Los Angeles Regional Water Quality Control Board

SUBJECT: REVIEW OF DRAFT REMEDIAL ACTION PLAN; CLEANUP AND ABATEMENT ORDER NO. R4-2021-0079 AMENDMENT

SITE: SKYPARK COMMERCIAL PROPERTIES (ASSESSOR PARCEL NO. 7377-006-906), 24701 – 24777 CRENSHAW BOULEVARD AND 2530, 2540, AND 2600 SKYPARK DRIVE, TORRANCE, CALIFORNIA (SCP NO. 1499, GLOBAL ID NO. T10000014333)

Attachment 1 - Figure 18 – Proposed Annual Soil Vapor Monitoring

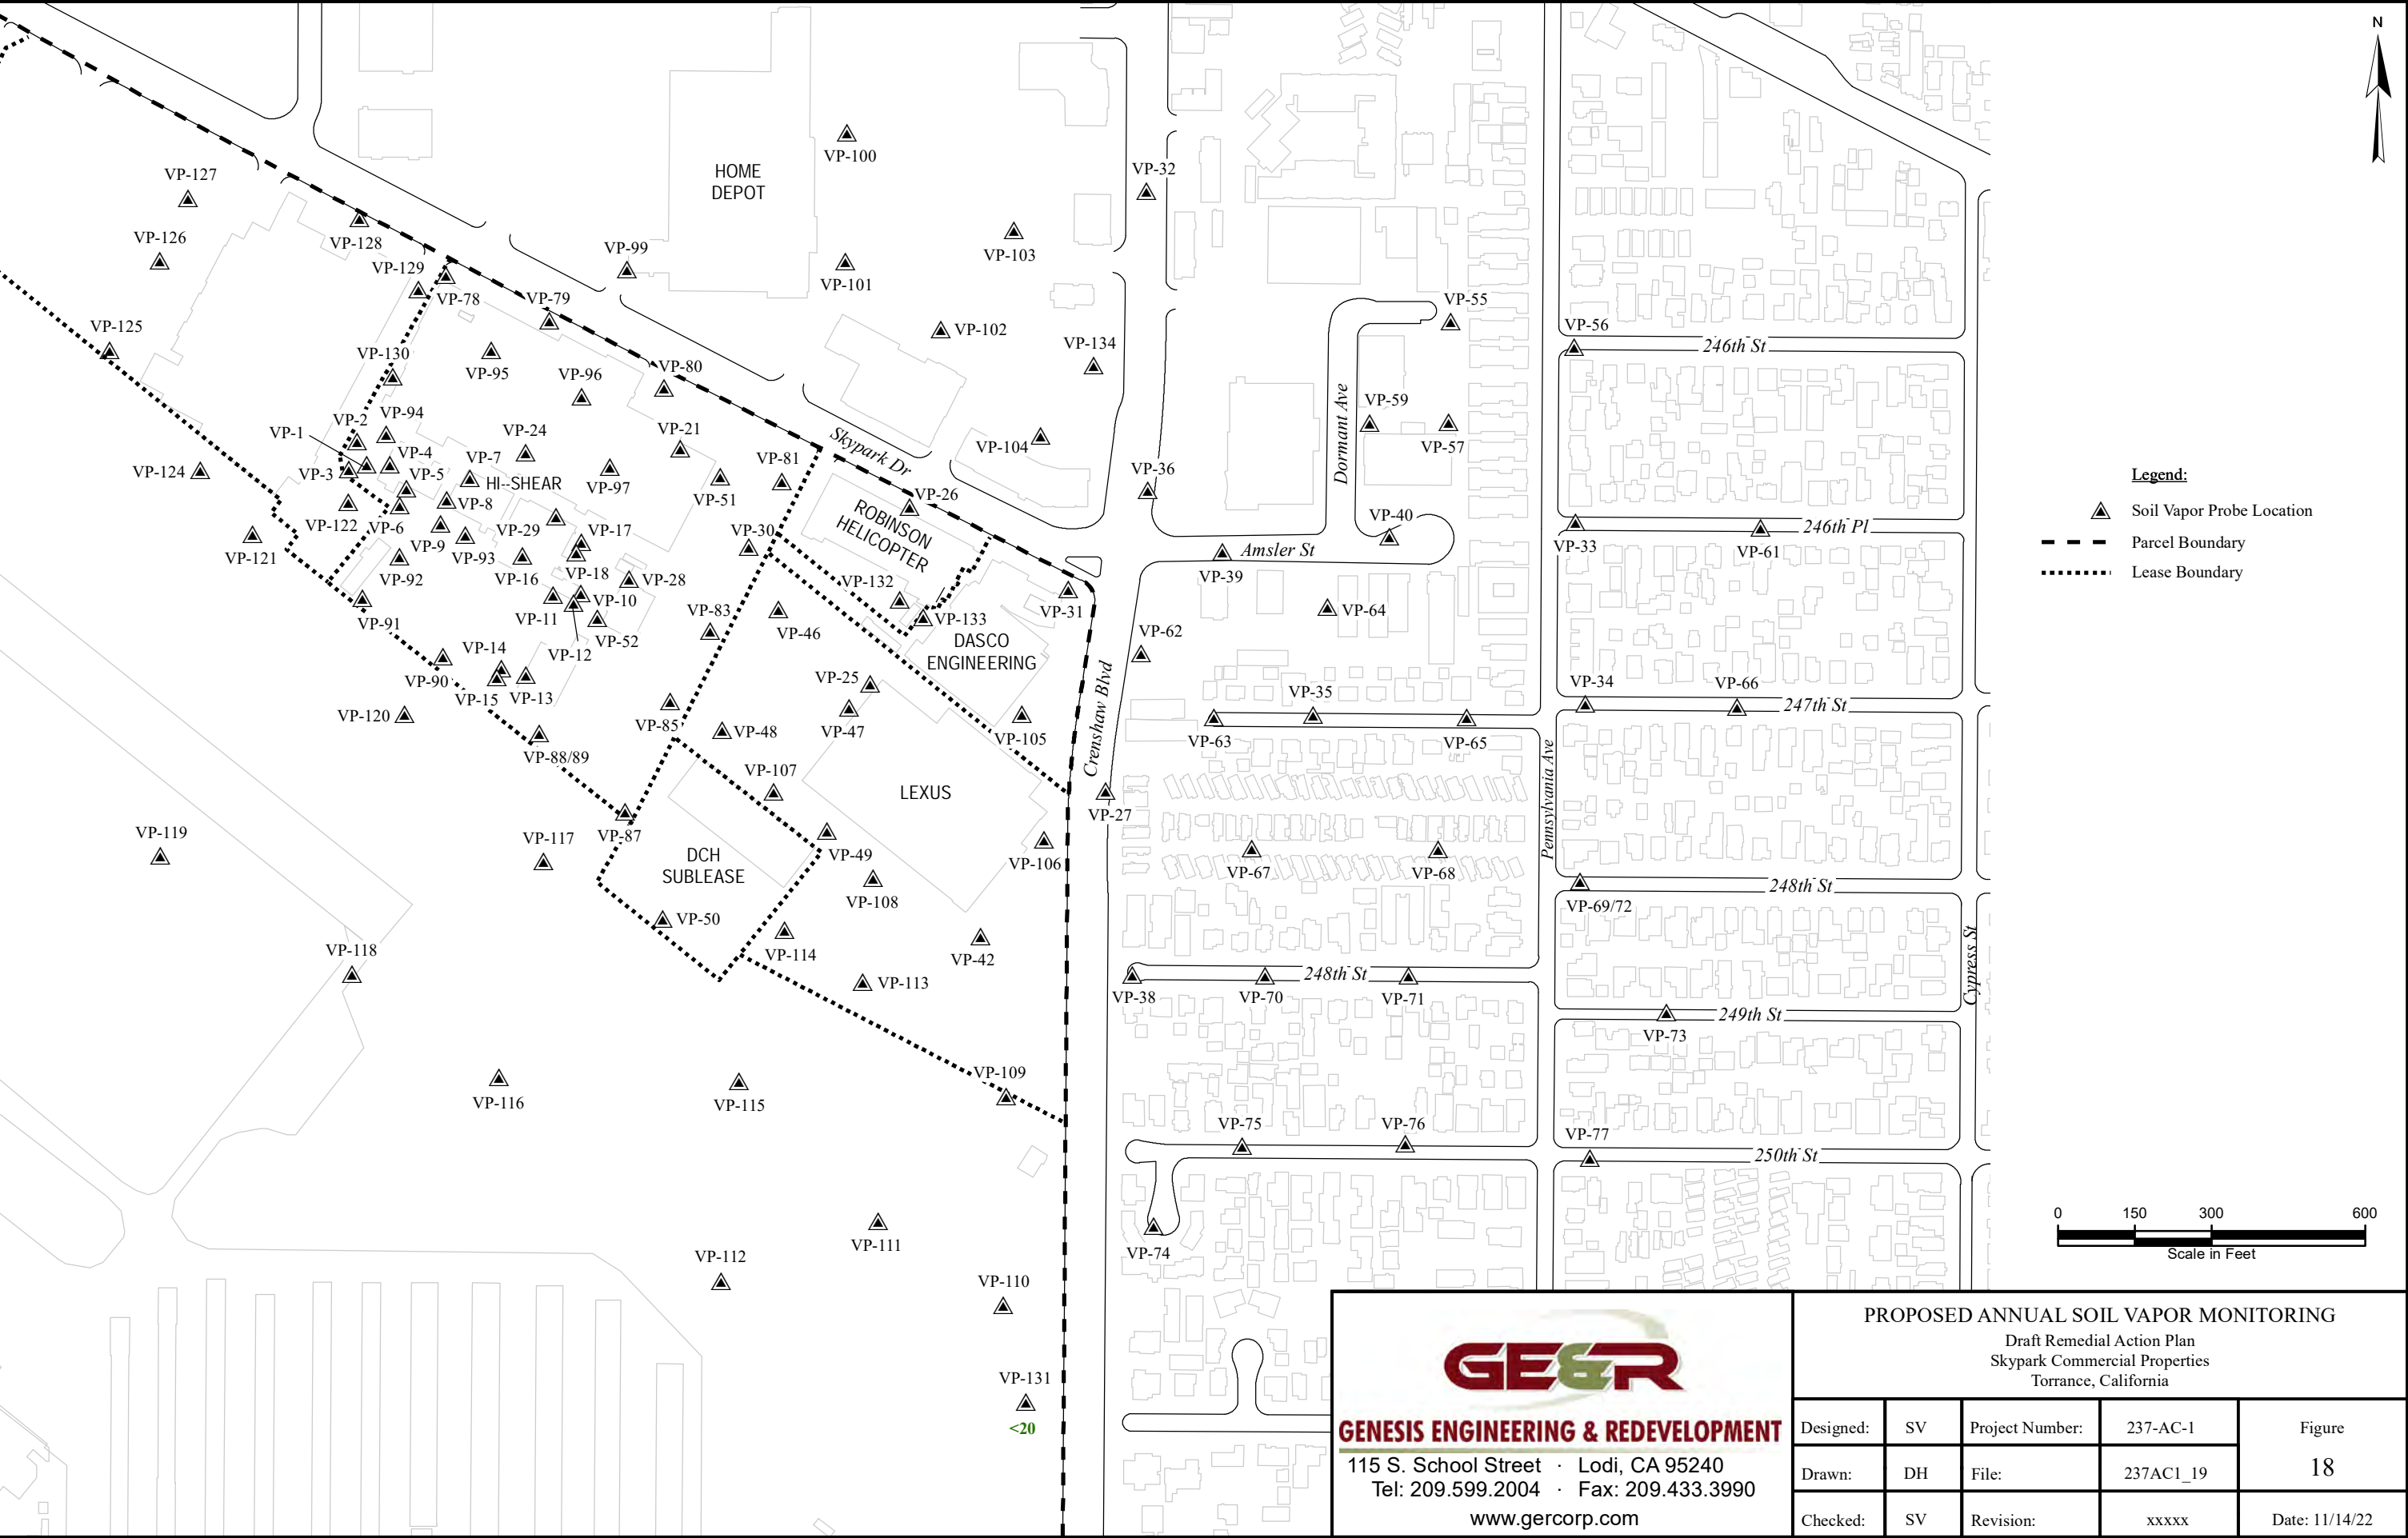
The Draft RAP proposes to sample all soil vapor probes associated with the Site on an annual basis, as shown in Attachment 1, *Figure 18 – Proposed Annual Soil Vapor Monitoring* (Figure 18). Soil vapor samples will be collected from all probes at each location and will be analyzed for VOCs by a mobile laboratory. Soil vapor probes installed in the future will be incorporated into the proposed Site-wide annual soil vapor monitoring program. The monitoring program will be reassessed following the first comprehensive round of sampling. The Draft RAP notes that periodic sampling of soil vapor probes necessary for the evaluation of remedial system(s) (i.e., soil vapor extraction [SVE]) will be coordinated with the Site-wide soil vapor monitoring to avoid duplication of efforts.

4. The Los Angeles Water Board conditionally approves the proposed Site-wide soil vapor monitoring program with the following comments and requirements:

- a. Soil vapor probes on public properties east of Crenshaw Boulevard shall be monitored as follows:
 - i. Soil vapor probes (at 5 and 15 ft-bgs) identified and conditionally approved in the Los Angeles Water Board letter, dated November 15, 2021, shall continue to be monitored on a semiannual basis. Deep soil vapor probes (i.e., greater than 15 ft-bgs) at these locations shall be monitored on an annual basis.

- ii. Soil vapor probes across all depths on public properties east of Crenshaw Boulevard that were not identified in the conditional approval, dated November 15, 2021, shall be monitored on an annual basis.

- b. Soil vapor probes across all depths west of Crenshaw Boulevard shall be monitored on an annual basis.
- c. Part of the conditional approval of the investigative component of the Revised EAP IRAP, dated July 27, 2022, was the collection of soil vapor samples from newly installed and existing soil vapor probes across all depths located on the EA Properties and the former Nike Missile Base. Part of the conditional approval of the *Revised Off-Site Assessment Work Plan* (Revised Work Plan), dated October 31, 2022, was the collection of soil vapor samples from newly installed and existing soil vapor probes on the Lowe's Property (i.e., 2700 Skypark Drive property). At the time of this writing, Los Angeles Water Board staff understands that the field activities for the soil vapor portion of the investigative component of the Revised EAP IRAP have not been completed. The annual and/or semiannual soil vapor monitoring, as conditionally approved in this letter, shall be coordinated, and carried out with the soil vapor sampling portions of the investigation component of the Revised EAP IRAP and Revised Work Plan to minimize duplication of efforts, where appropriate.

Attachment 2 - Figure 21 – Proposed Perched Groundwater Wells Beneath the HSC Property

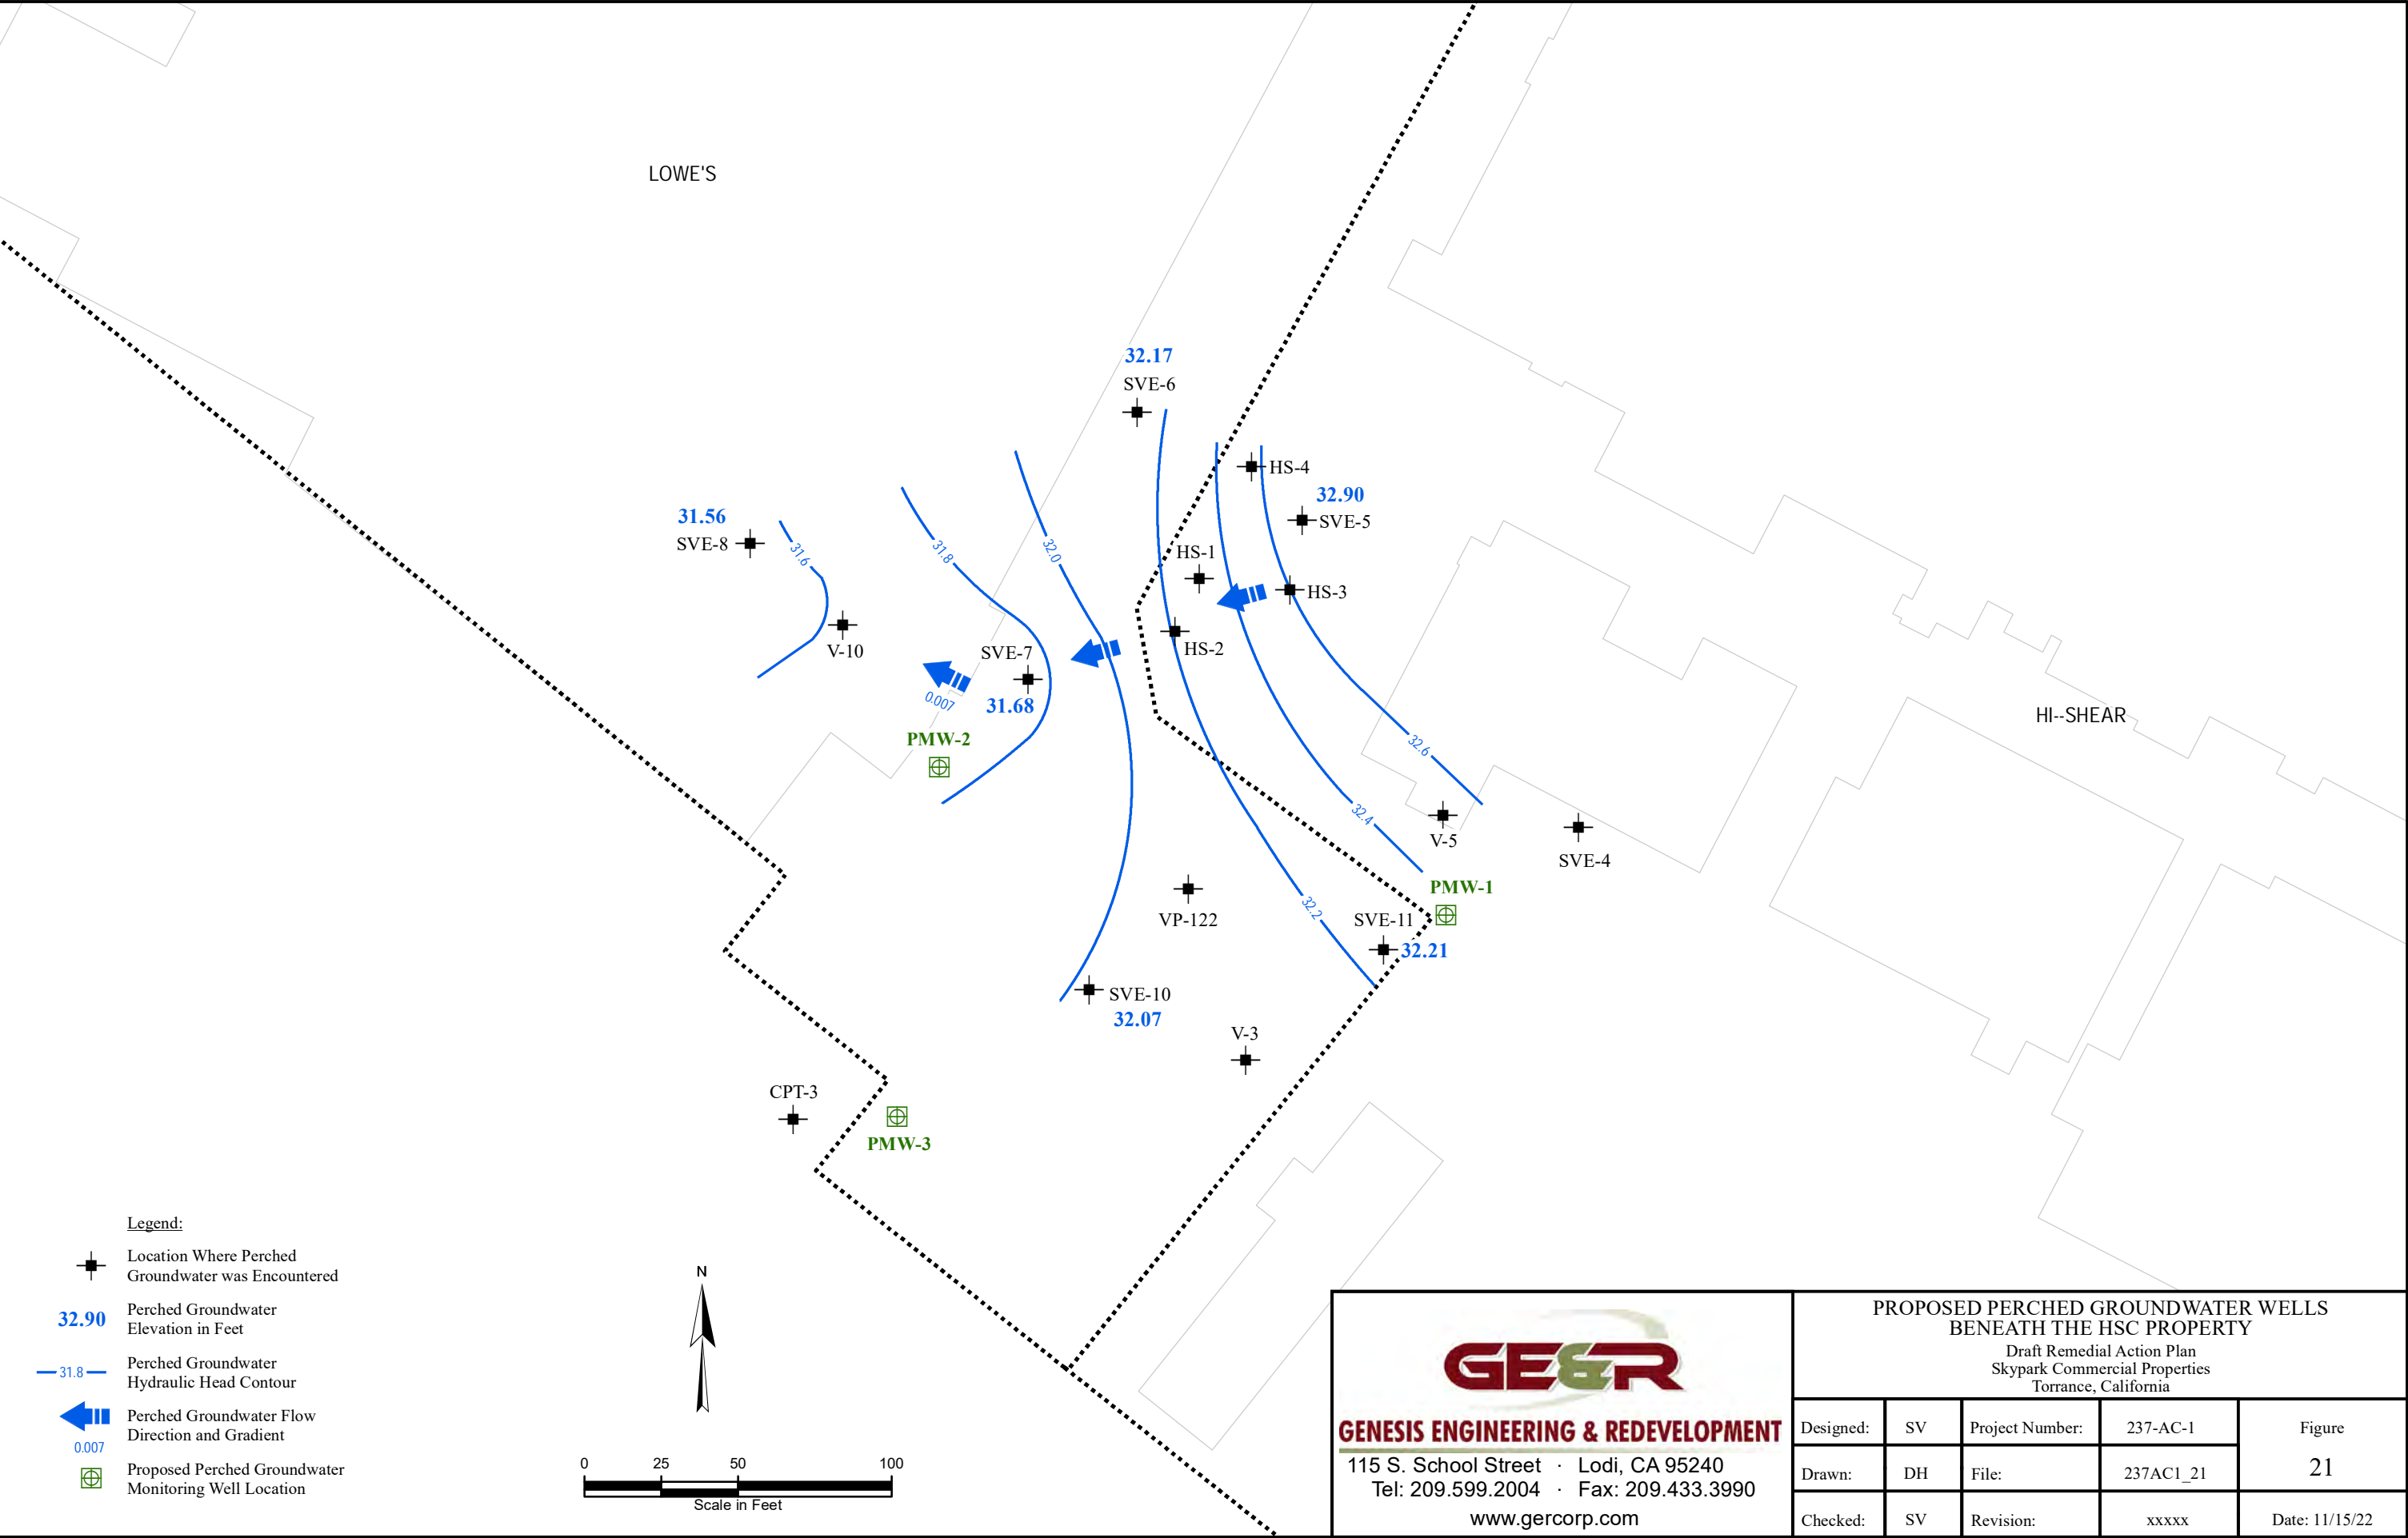
1. Perched groundwater beneath the Hi-Shear property.
 - a. Install three perched groundwater monitoring wells (PMW-1 through PMW-3), as shown in Attachment 2, *Figure 21 – Proposed Perched Groundwater Wells Beneath the HSC Property* (Figure 21).

5. The Los Angeles Water Board conditionally approves the proposed scope of work to assess the perched groundwater beneath the HSC property, as shown in Figure 21, with the following comments and requirements:
 - a. The proposed locations are in an area with limited environmental data and/or proximal to Areas of Potential Concern (AOPC), AOPC-1 and AOPC-

2, and former Building No. 4. These areas have historically been associated with TPH, VOCs, and perchlorate; therefore, soil samples shall be collected at 5-foot intervals to total depth during installation of groundwater monitoring wells and be analyzed for VOCs, perchlorate, and TPH using United States EPA Method 8260B, 314.0, and 8015M, respectively.

- b. Submit a report, at a minimum documenting the results of the perched groundwater assessment, field observations, laboratory data, conclusions, and recommendations. Task 3.a. – Site Assessment (i.e., vertical and lateral delineation) of the Order is the underlying requirement of this proposed scope of work.
